**PLANNING APPLICATION P17-204**

**15 LAYCOCK STREET, LONGFORD**

15 Laycock Street, Longford - Applicant response to representation received to Planning Application P17-204 - Multiple dwellings x 5 & new access (vary side [N & S] setbacks & widow/access separation)

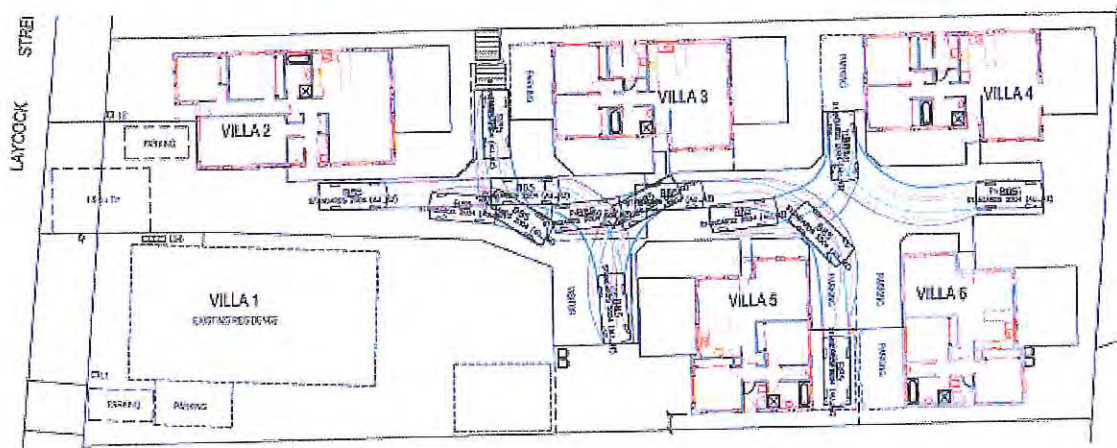
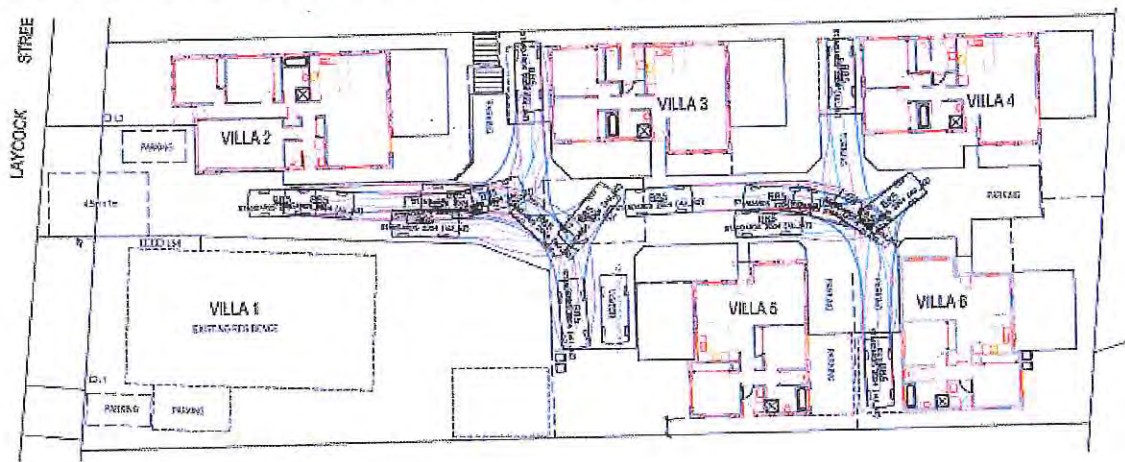
From the plans submitted, it appears that the required turning circles as per standards seem not to comply.

3.1 - The provision of appropriate turning circles improves the amenity and safety of a multiple dwelling development by allowing cars to exit driving forwards, and as a result has had significant consideration in the layout design.

3.2 - The provision of turning was reviewed and approved by Council against the access widths specified in Table E6.1 of Car Parking and Sustainable Transport Code.

3.3 - Council's assessment was supported by parking turning circle drawings as part of the development application (see below), prepared in accordance with Australian Standards using Transoft Solutions software.

3.4 - Turning movements have also been provisioned adjacent to landscaped gardens, as opposed to immovable buildings or fences to provide additional driver ease/comfort.

**Shadow Plan 2: 21<sup>st</sup> June, 12:00 PM**

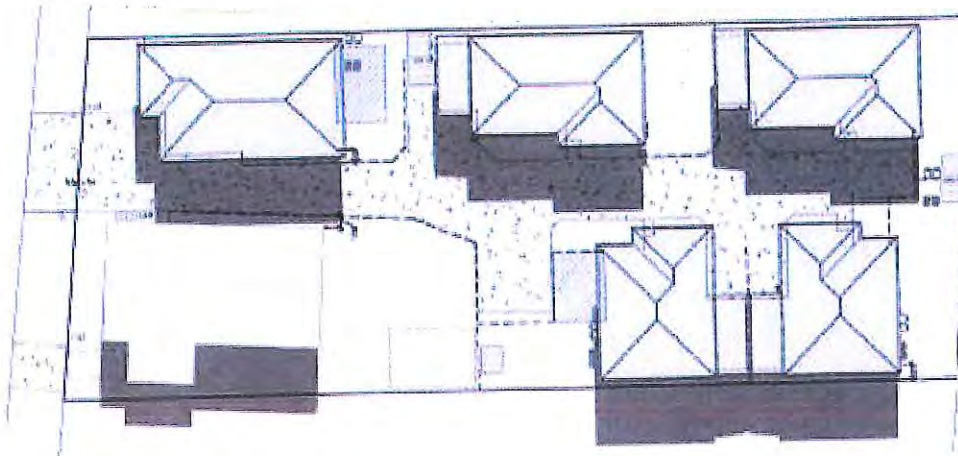
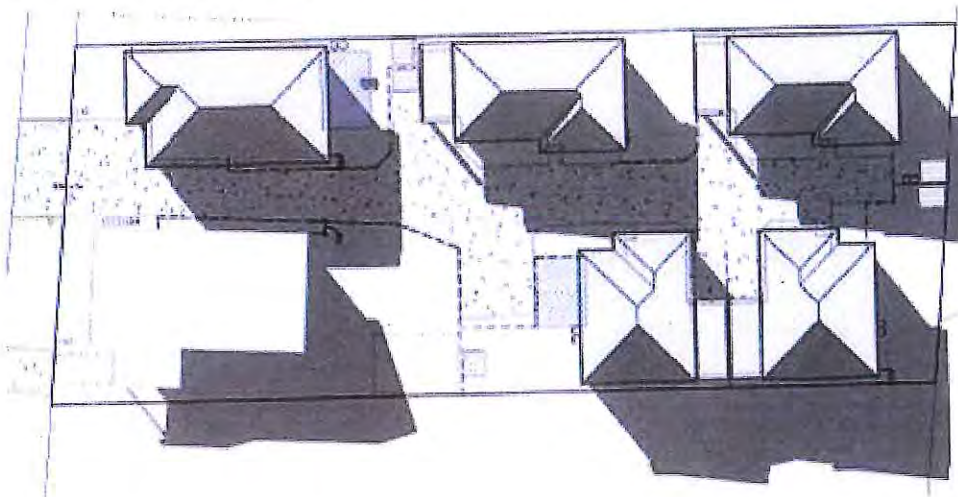
I feel that with the intended dwellings being built so close to my boundary, and given that they will be at least 300mm above normal ground level, I fear that my home will be severely impacted by over shadowing, and this will lead to further loss of amenity to my home. I saw no "shadowing plans" in this application, and I am of the view that this is a considered omission to further assist the application.

5.1 - Shadowing is not an issue to either of the neighbouring properties due to the fact shadows in Tasmania are cast in a southerly direction and the neighbour's dwelling on the southern side is not within range of shadows cast.

5.2 - Council's Planning Department are required to assess whether shadowing could be an issue, but based on their judgement they did not request a shadowing plan to be prepared for this development application.

5.3 - Despite this I have engaged a drafter (at my cost) to prepare shadow plans to address the neighbour's concerns, as shown below.

**Objection #9 – Loss of amenity #2**

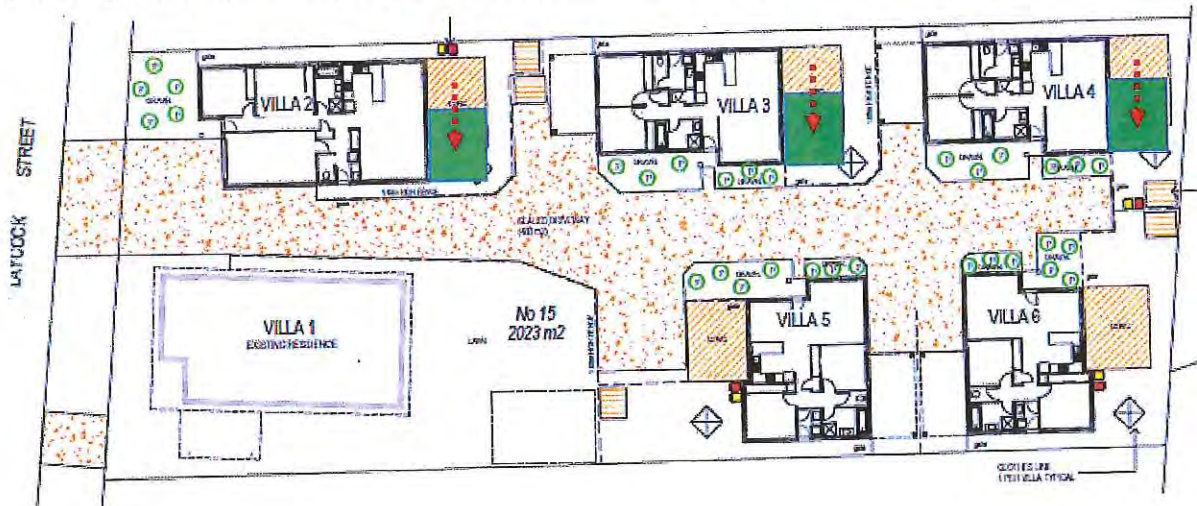
With minimal boundary setbacks on my boundary, my hobbies and interests will have a negative effect on the occupants of the proposed development. This will undoubtedly lead to complaints and possibly conflict and will again erode my ability to use my home for my own enjoyment.

9.1 - Any hobbies and interests currently undertaken should not be an issues, as long as they comply with Local Council’s requirements and allowed activities within the township of Longford.

9.2 - The existing garden beds, established hedges, and trees along the northern neighbour’s fence line provide natural separation (as shown previously); which will be supported further by the addition of lattice atop the fence (see item 7.5)

9.3 - I am willing to relocate the private open space areas away from the fence (see image below) to provide greater separation (and privacy) between congregation points from the neighbour’s yard.
